SUBJECT: PLANS AND PROPOSAL ADDENDUMS
PROJECT: STP 2023 (675)MM CONTROL: 1433-02-044
COUNTY: COMAL
LETTING: 05/04/2023
REFERENCE NO: 0419

PROPOSAL ADDENDUMS

DESCRIPTION OF ABOVE CHANGES
(INCLUDING PLANS SHEET CHANGES)

677-6003	ELIM EXT PAV MRK & MRKS (8")	LF	0
677-6007	ELIM EXT PAV MRK & MRKS (24")	LF	43
677-6008	ELIM EXT PAV MRK & MRKS (ARROW)	EA	0
677-6012	ELIM EXT PAV MRK & MRKS (WORD)	EA	0
677-6020	ELIM EXT PAV MRK & MRKS (MED NOSE)	EA	0

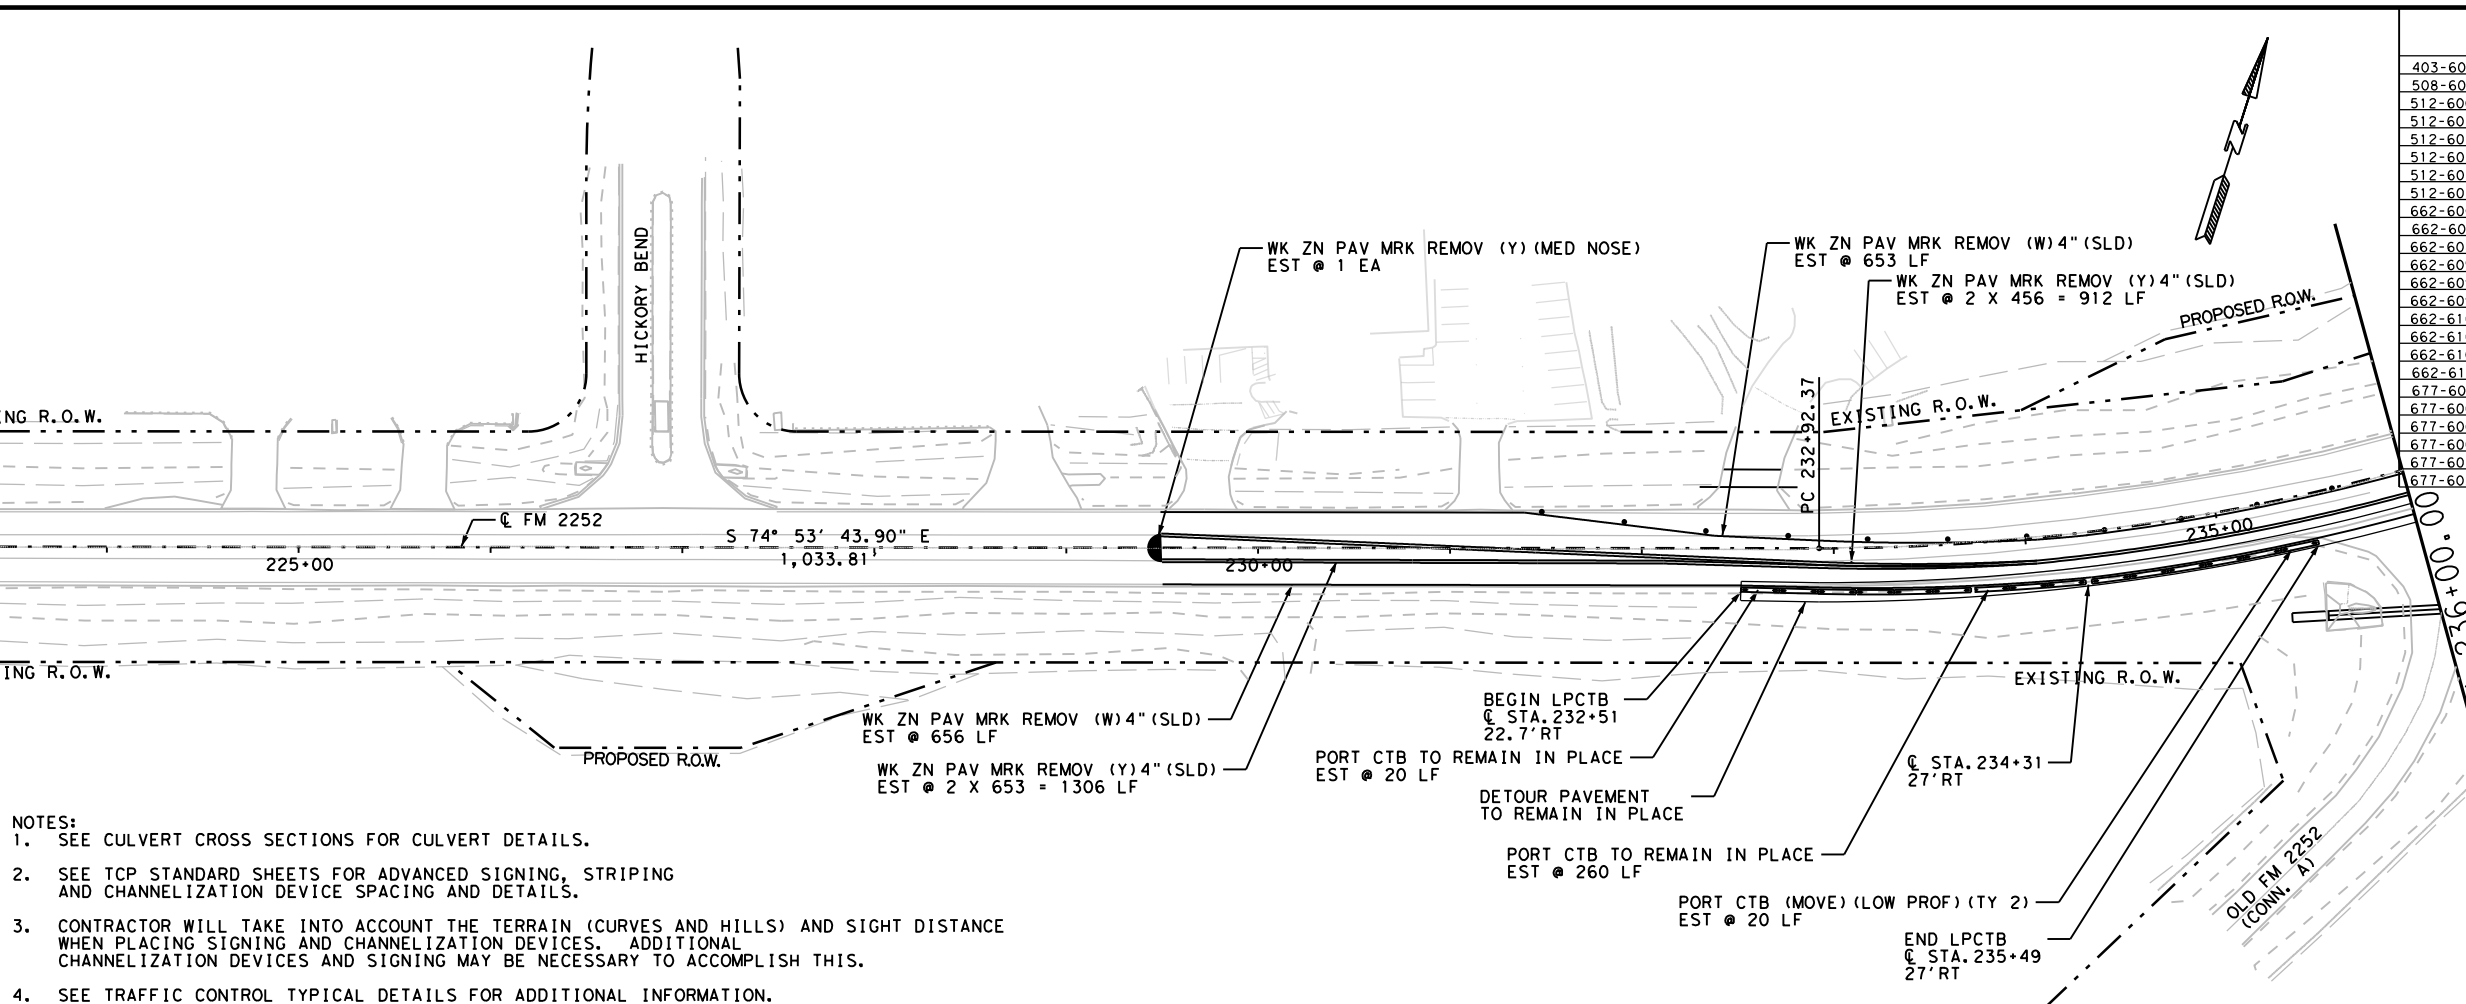
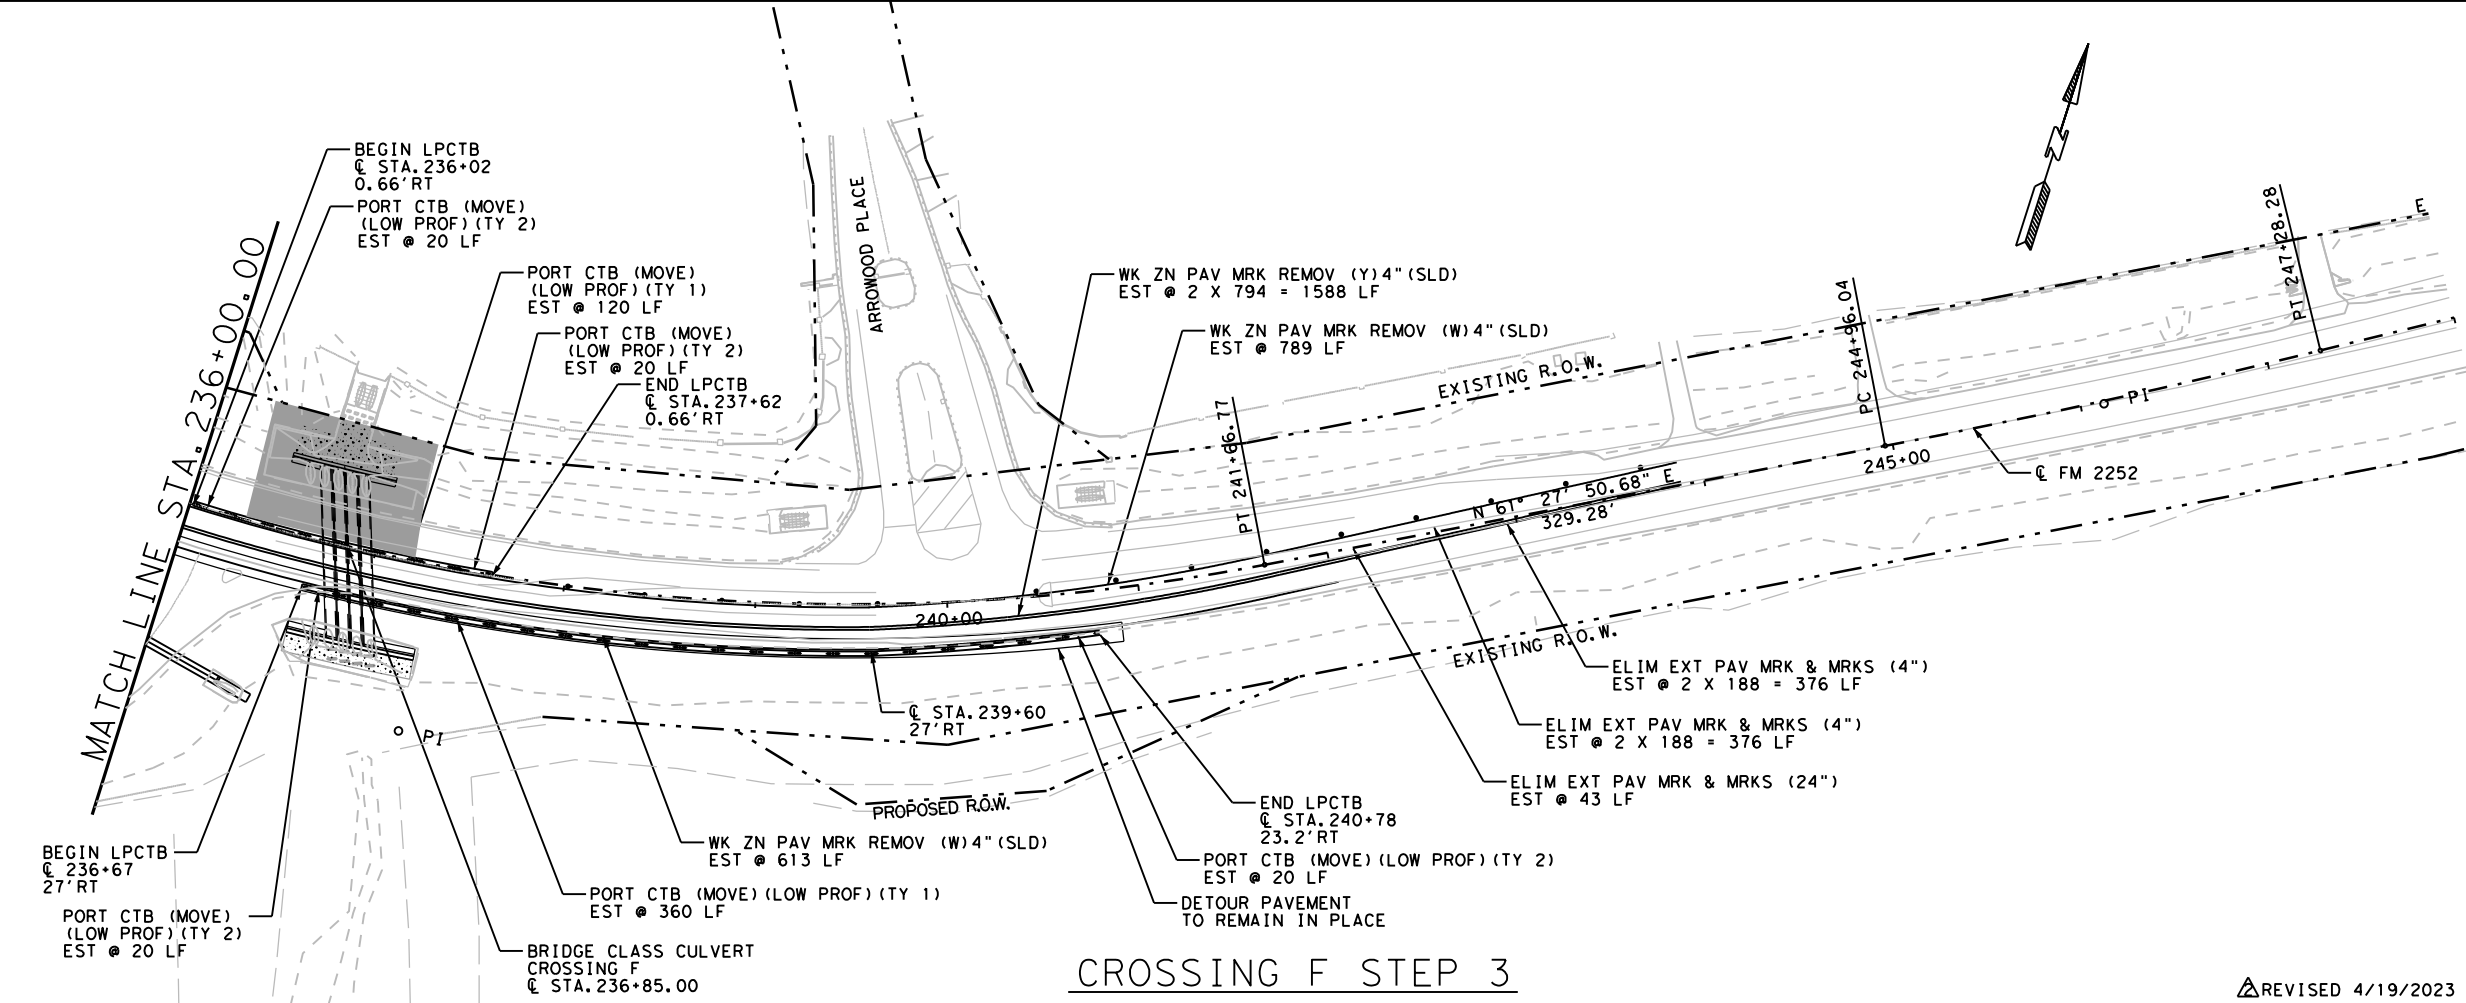
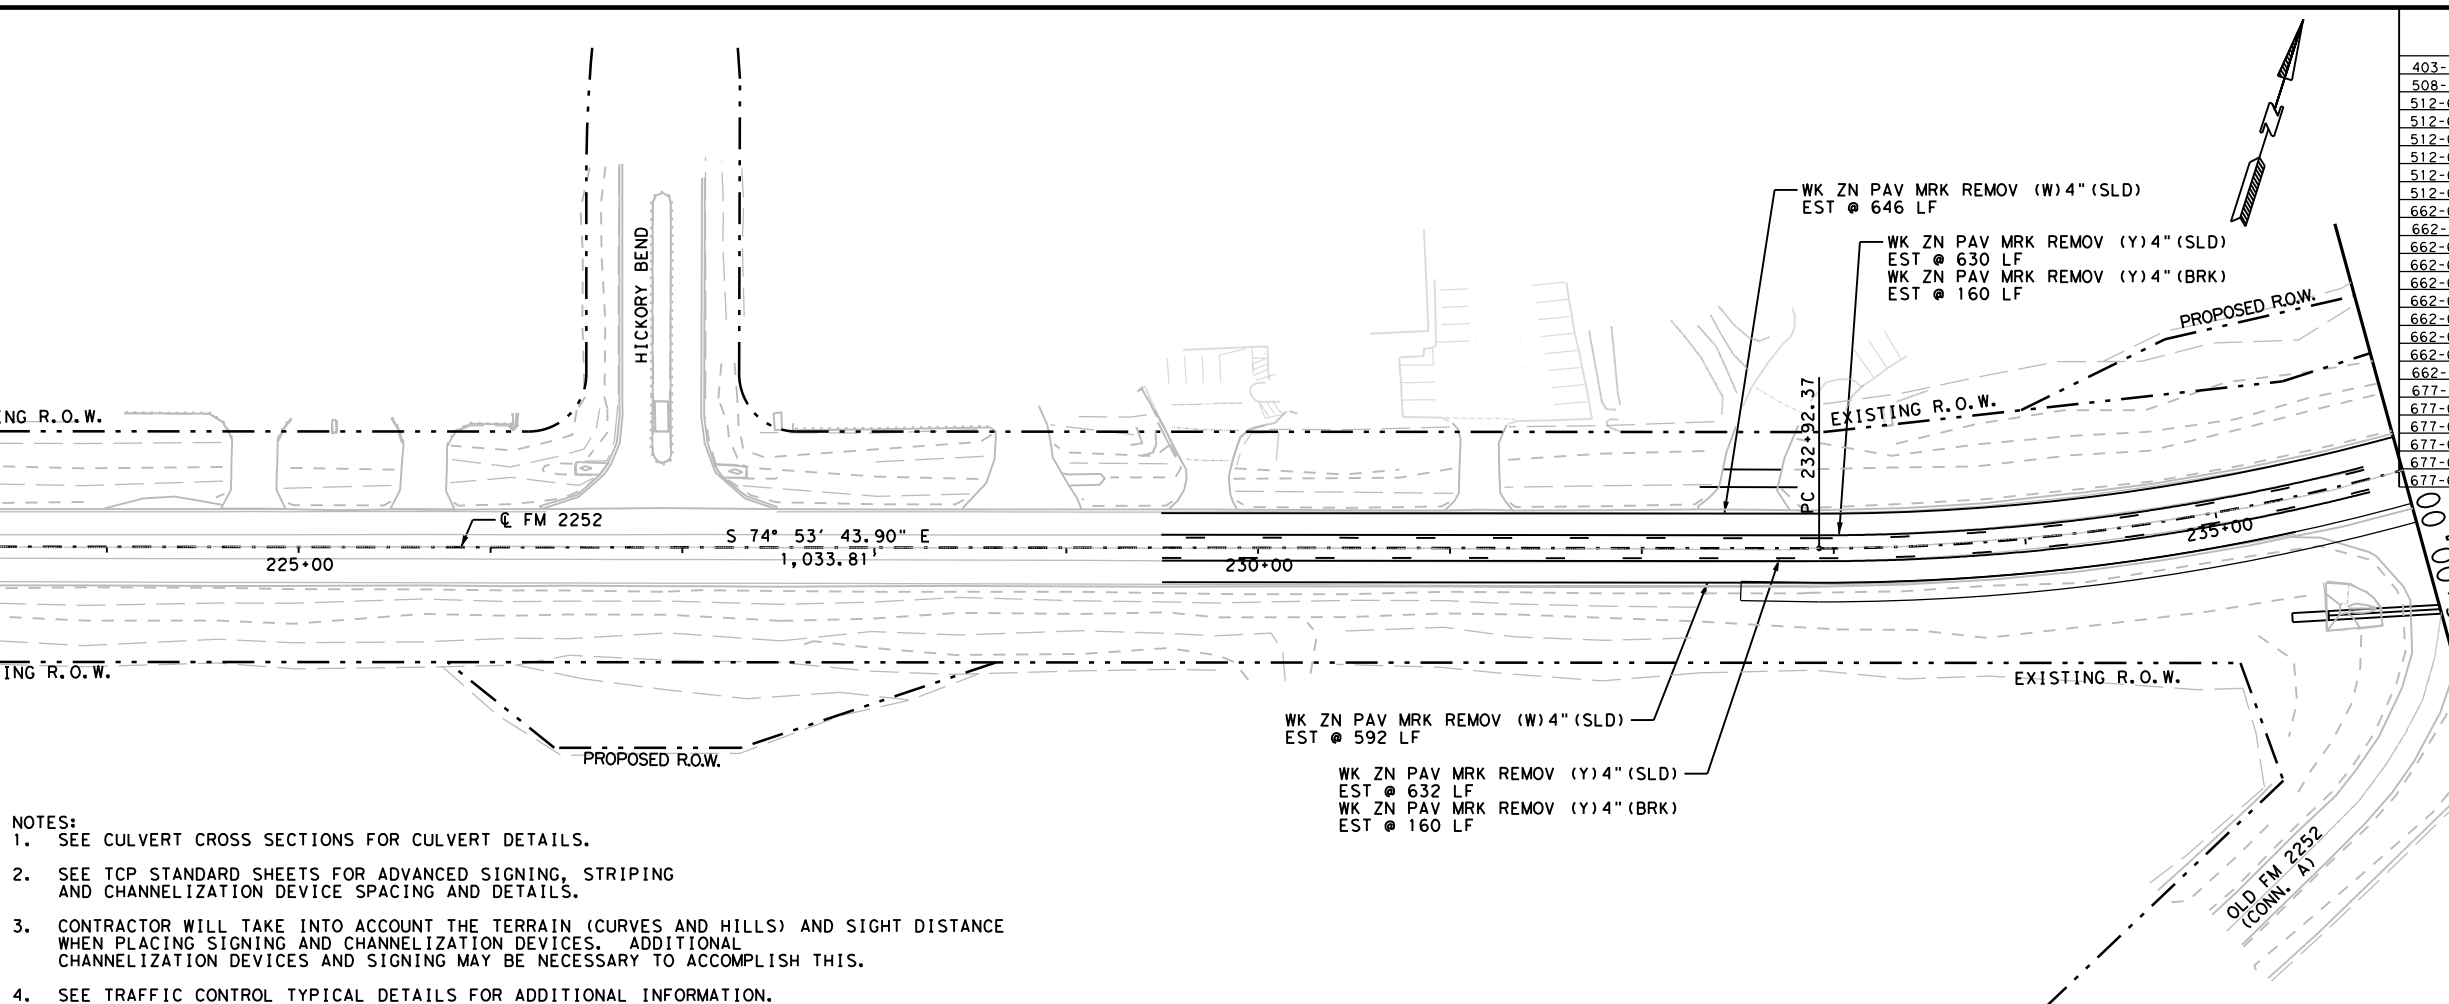
SHEETS 275-278, 280-283, 285-288 AND 290-293: ADDED ITEM NO. 403-6001
